Re: Calpine Geysers Units 3, 16, 17, 18, 19, and 20 License Amendments

Calpine Geyser's Units 3, 16, 17, 18, 19, and 20 Amendments

Prepared for
Calpine

June 18, 2003

Figure 5

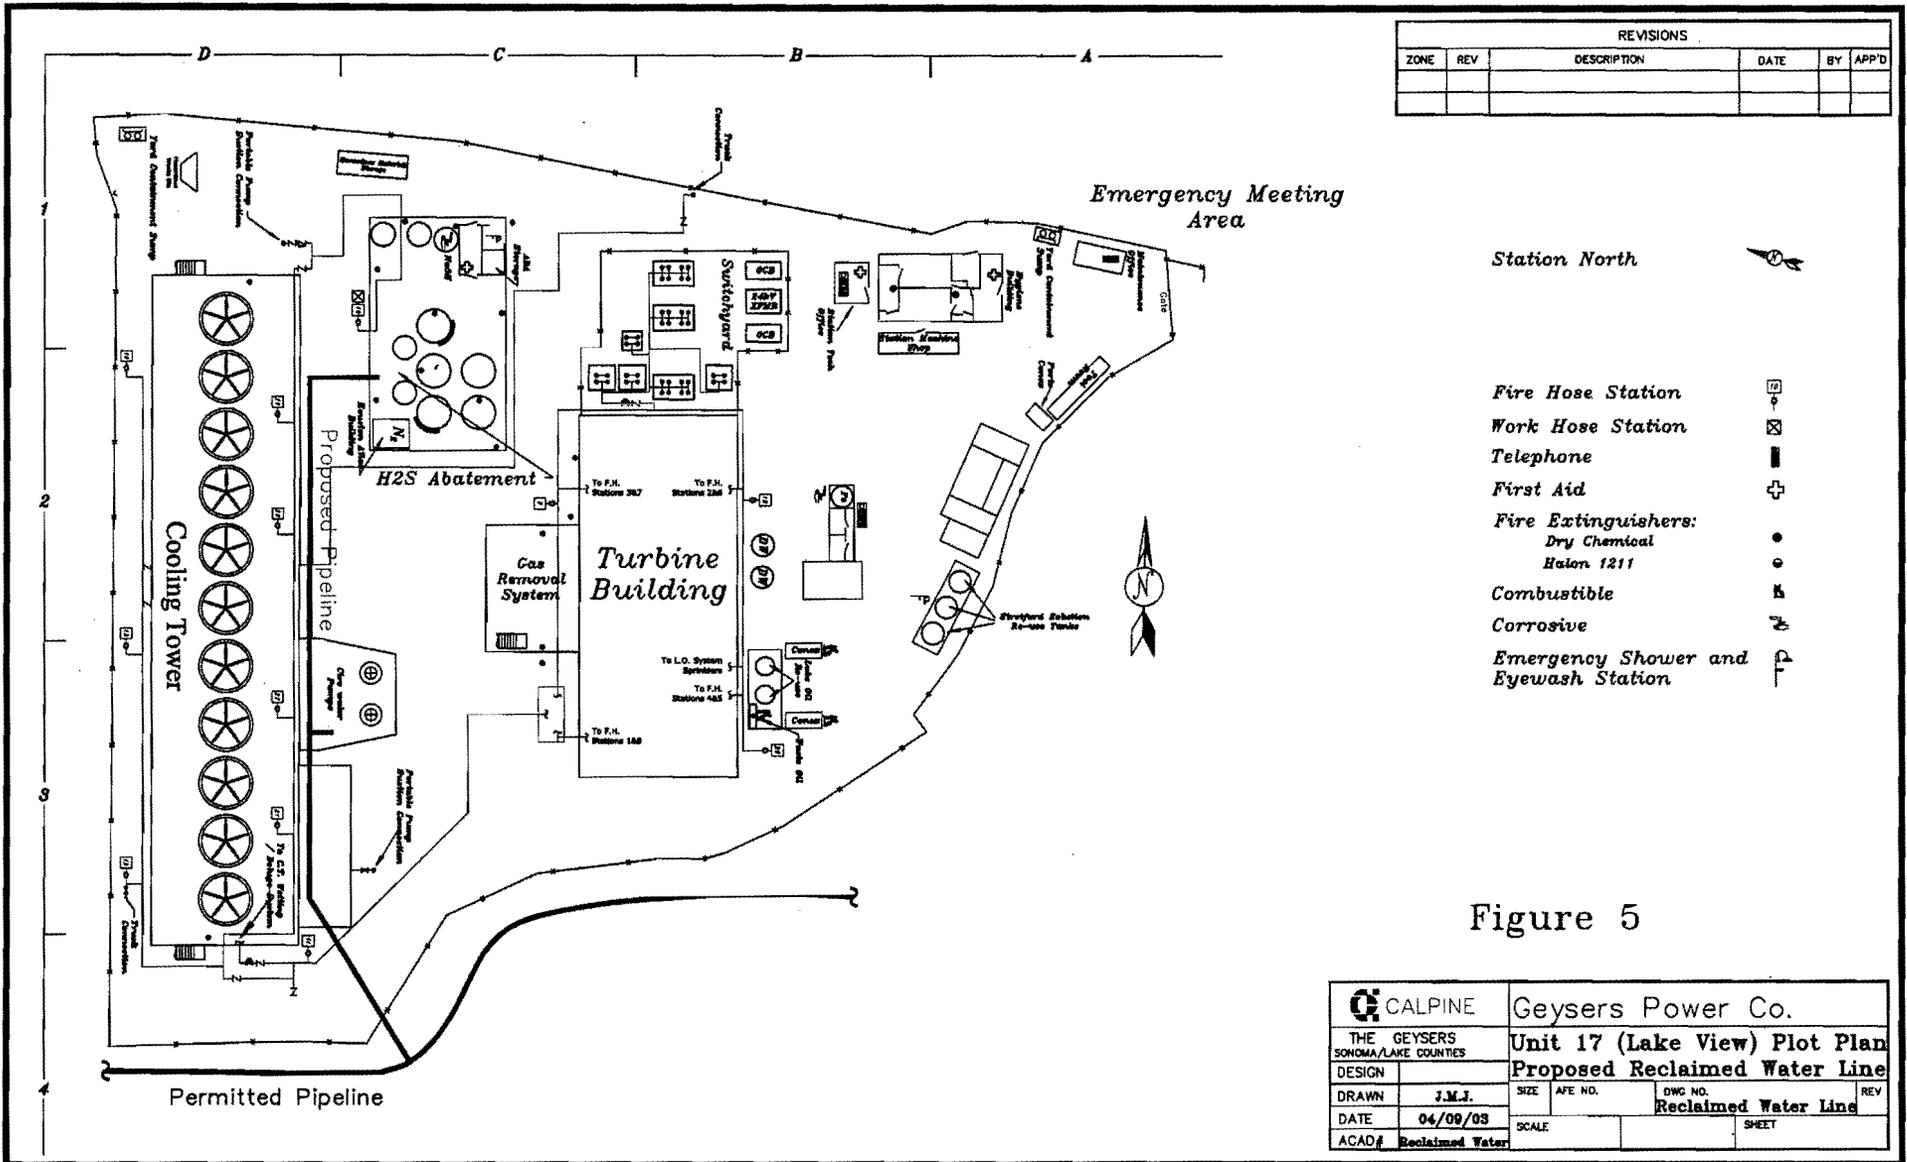
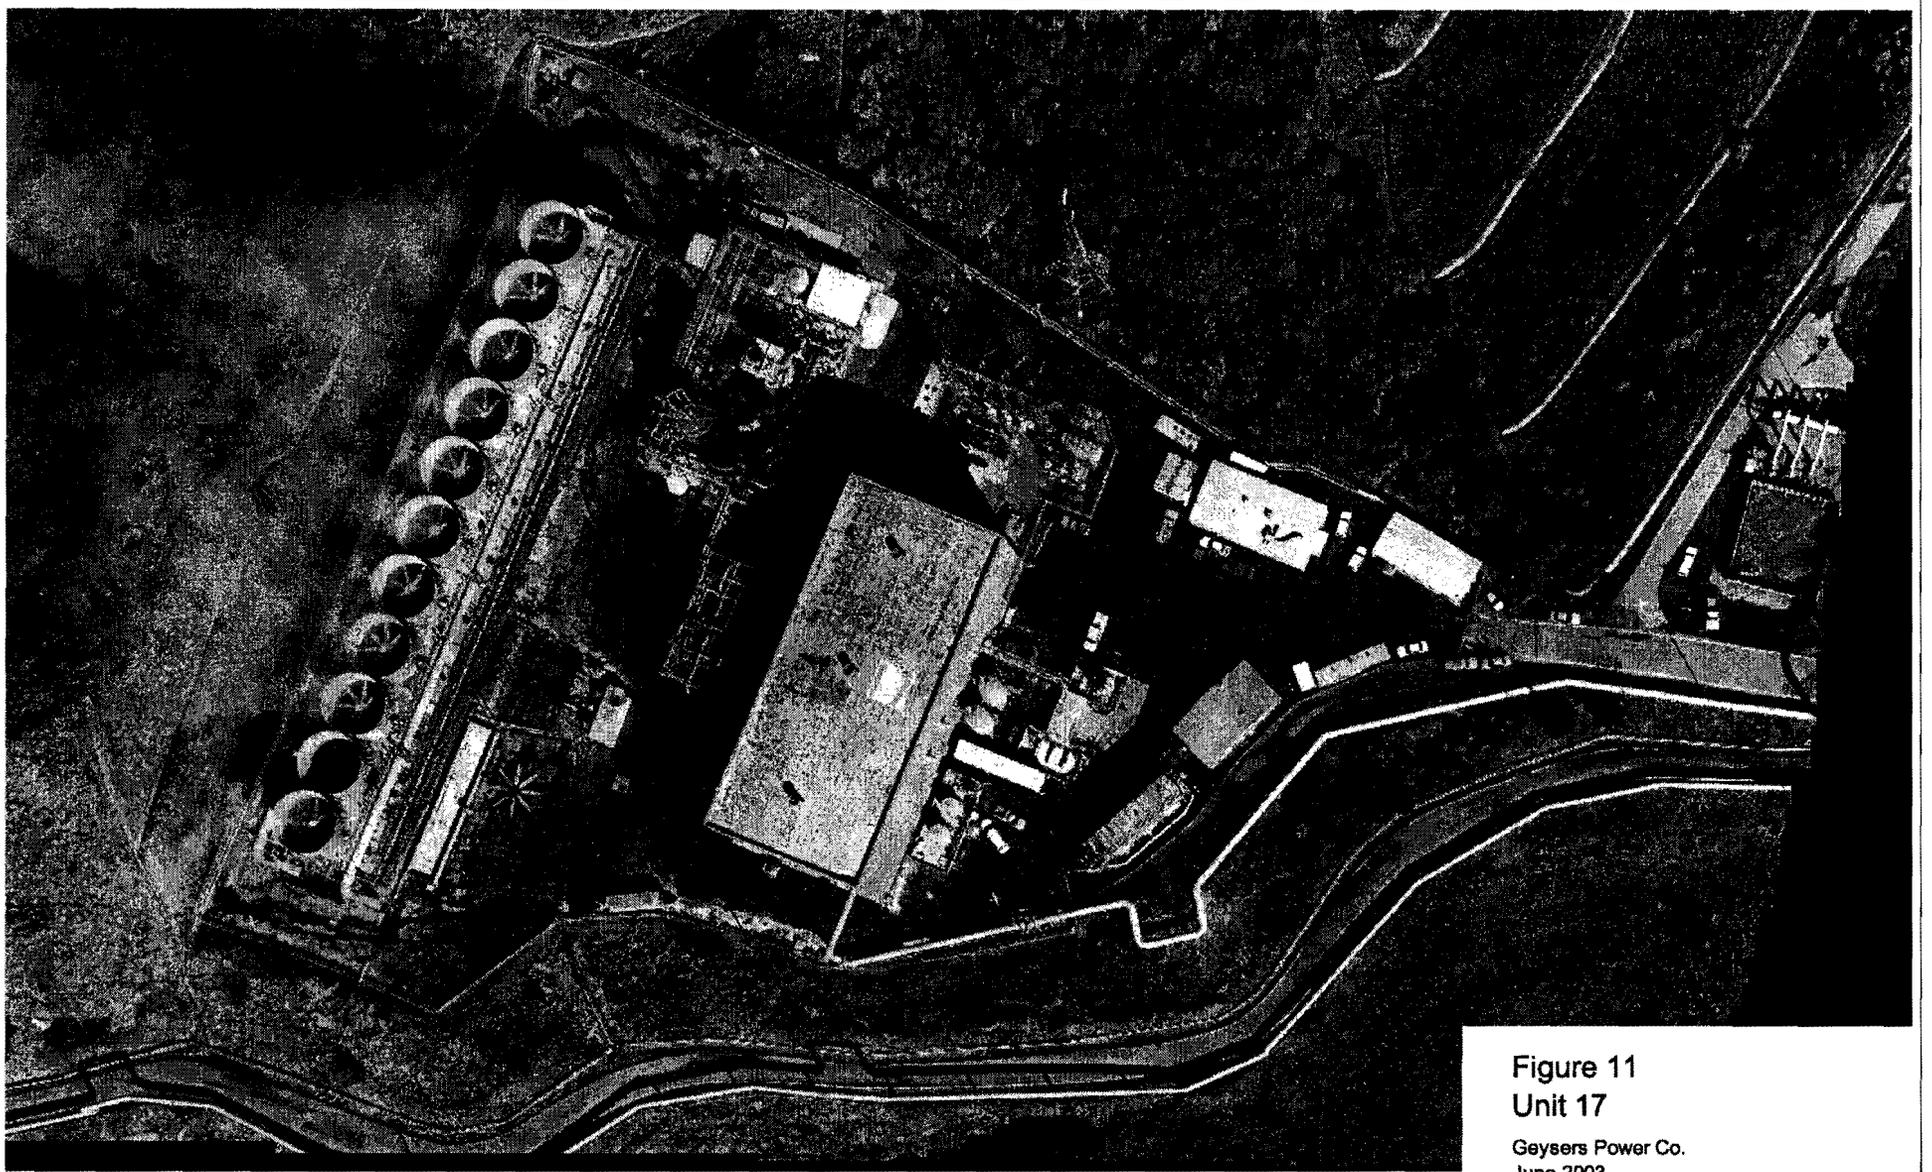
As shown in Figures 5 and 15, the existing water supply pipeline is located across an access road from Unit 17, and will be routed up a short slope to the project site (estimated offsite length is 75 feet). The proposed pipeline will interconnect to the existing supply pipeline above grade (approximately 3 to 4 feet above grade) and will be trenched across the road and will daylight on the other side of the road. The pipeline will then proceed up a short embankment above ground, anchored by concrete foundations every 25 feet. These foundations are approximately 1 foot square and 3 feet deep. The roadbed and embankment are both highly disturbed fill. The existing pipeline is located on the side of the existing access road. The

Figure 6

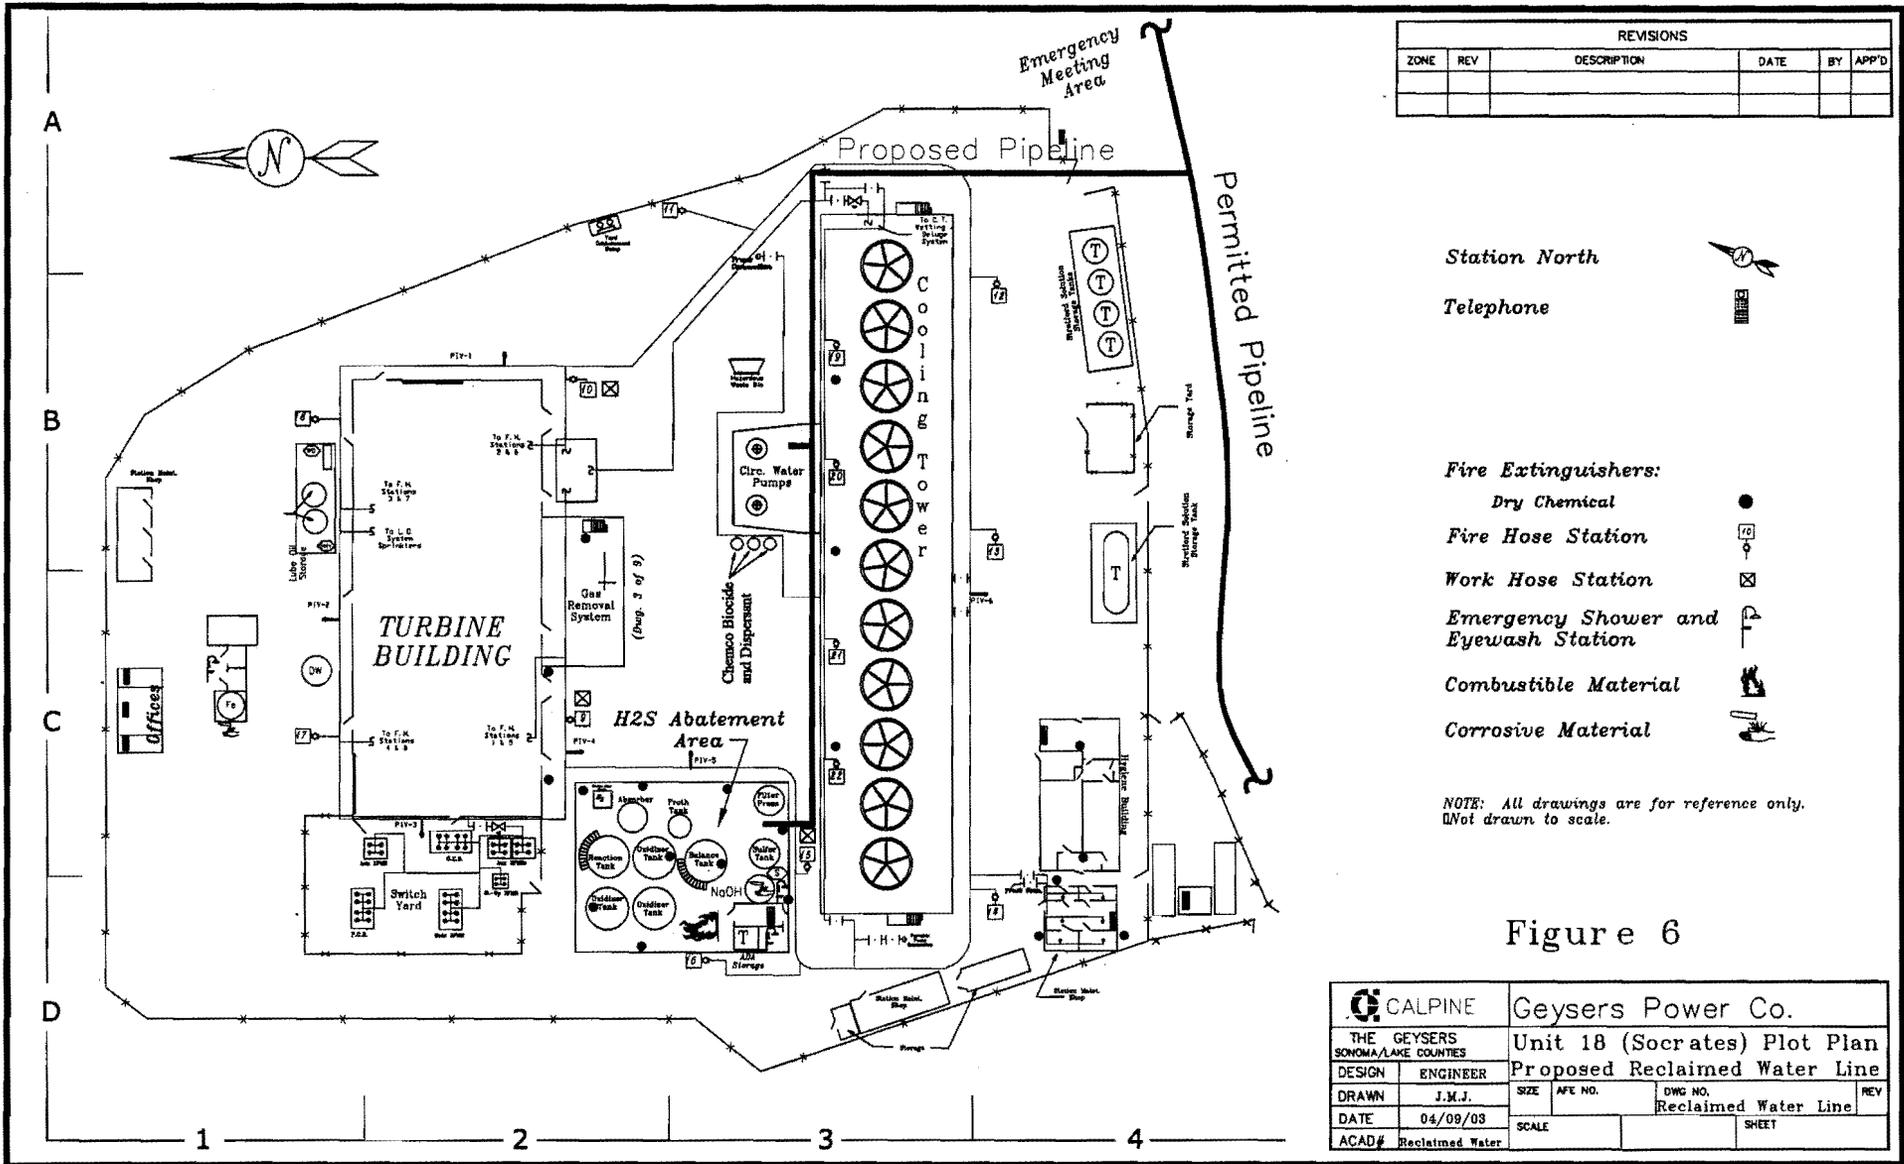
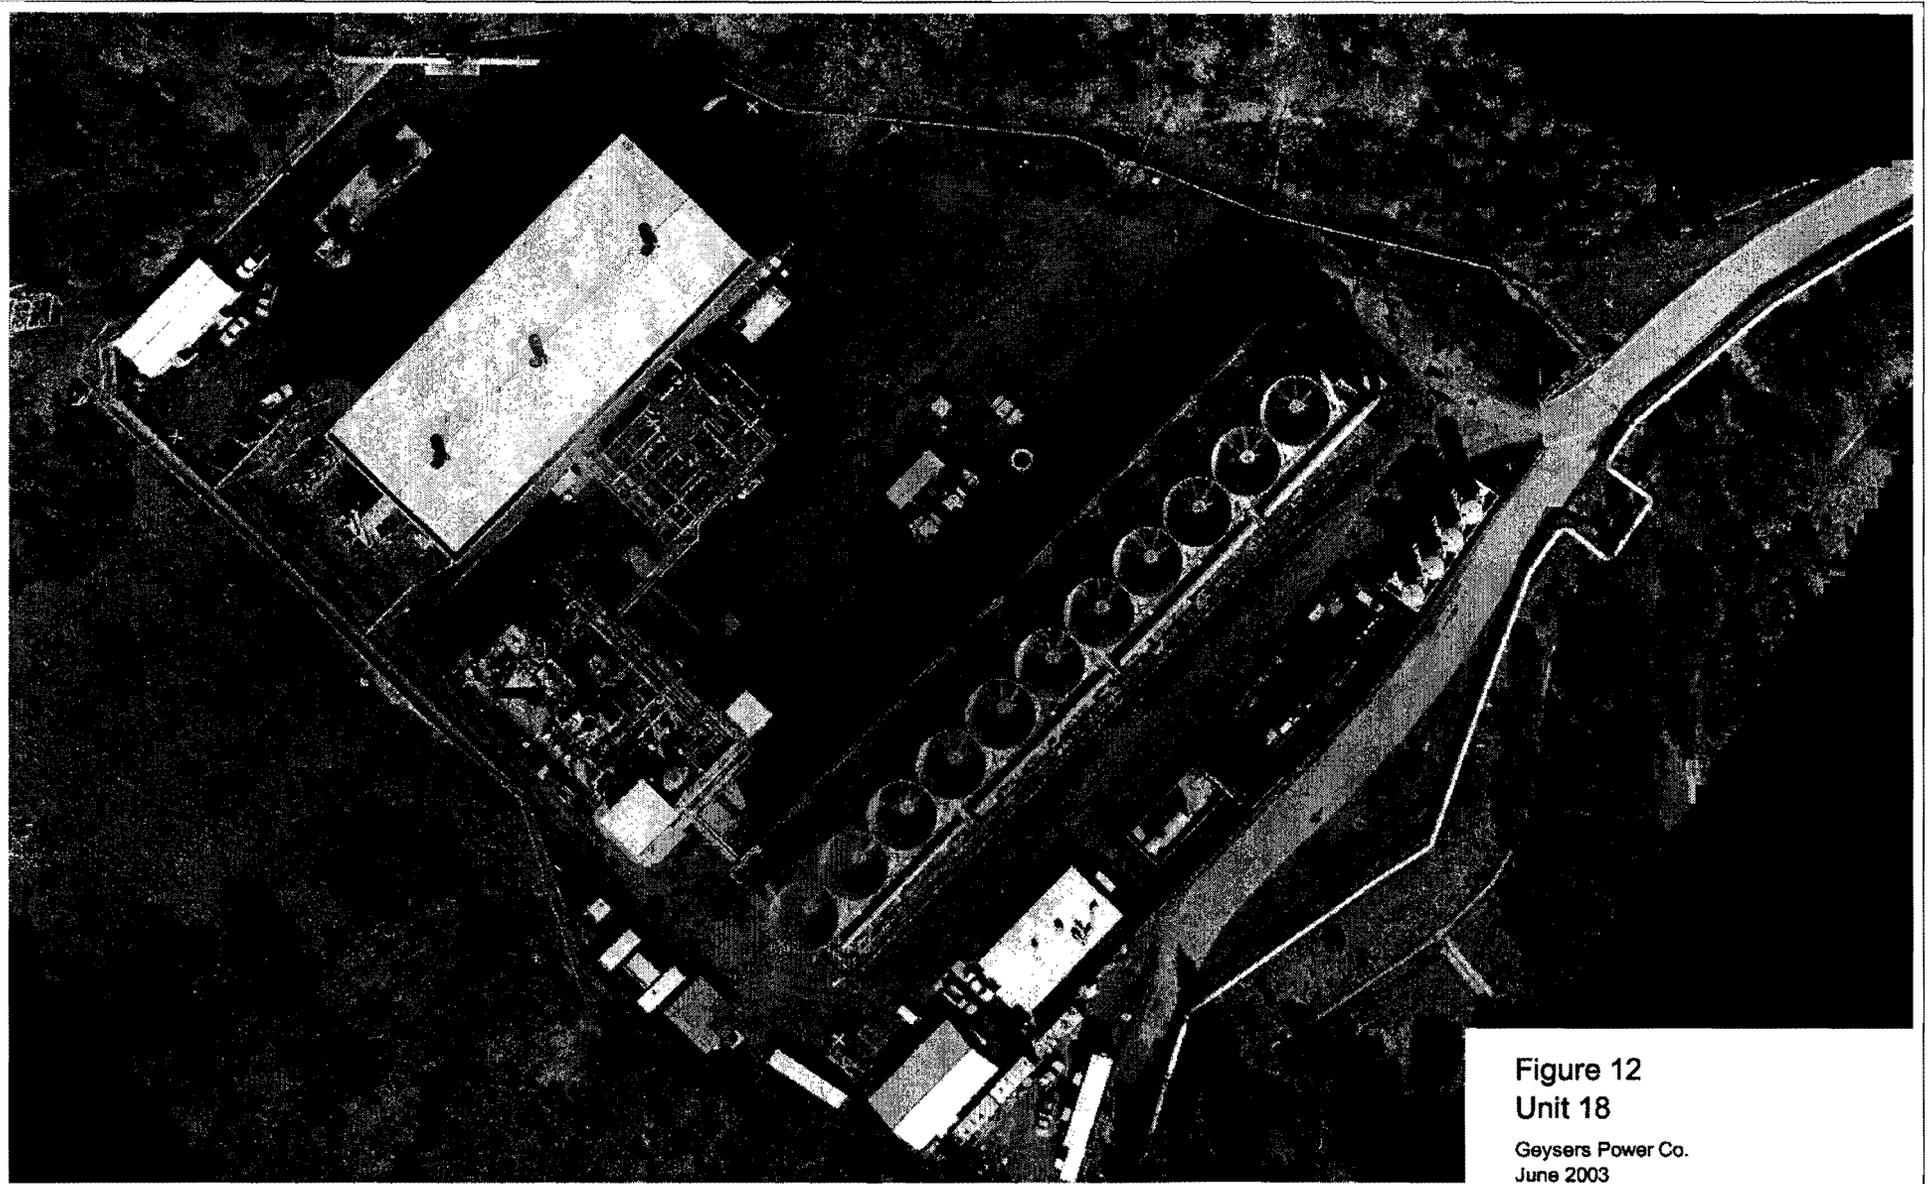
As shown in Figures 6 and 16, the existing water supply pipeline is located in the access road adjacent to Unit 18. The proposed pipeline will interconnect to the existing supply pipeline by trenching to the access road at a depth of approximately 3 feet directly to the west end of the cooling tower, where the pipeline will daylight and be above grade. The soils that will be disturbed in the roadbed and the plant site are highly disturbed due to the initial plant and road construction. Therefore, no cultural resource impacts are expected.

Figure 7

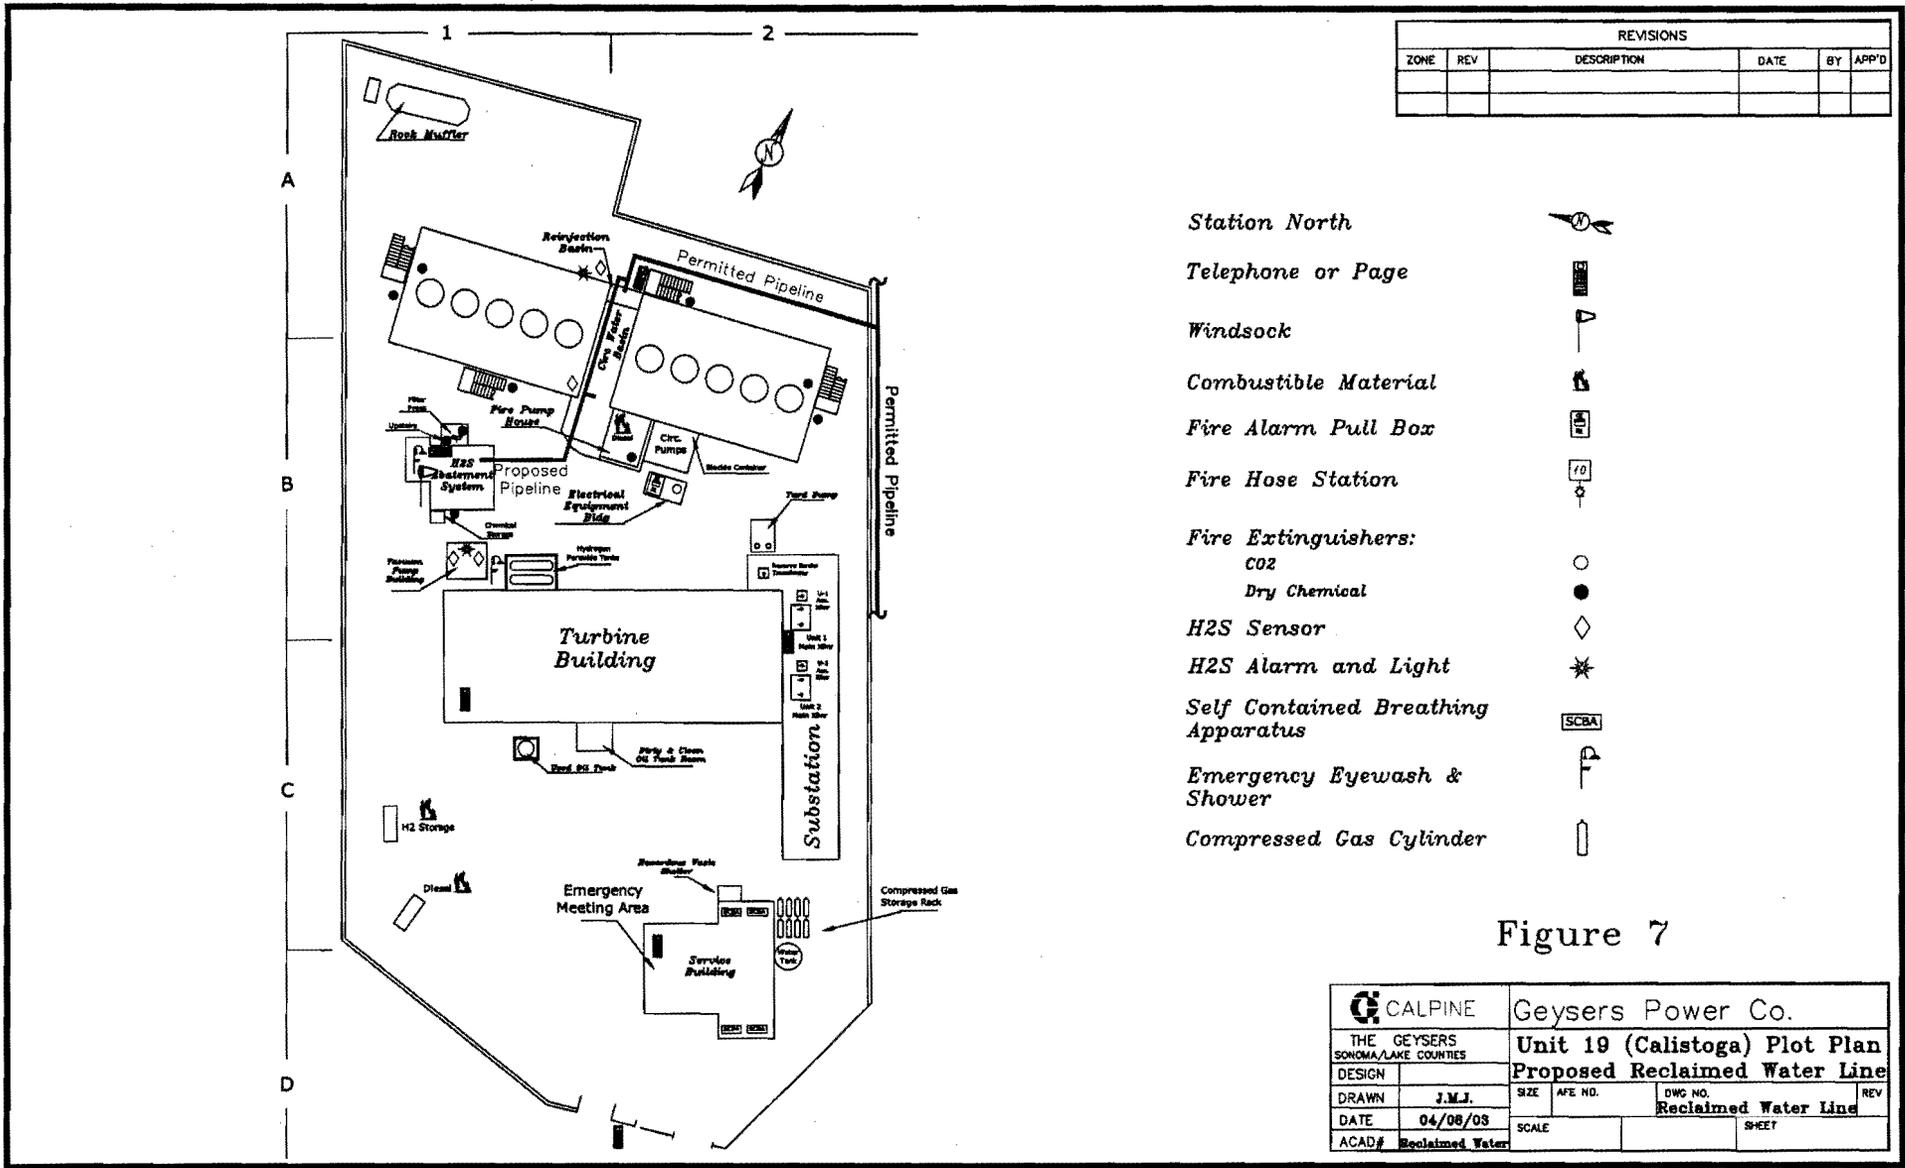
As shown in Figures 7 and 13, the recycled water supply pipeline is already on site and no ground disturbance is required on this Unit. Therefore, no additional construction will be required and no impacts to cultural resources are expected.
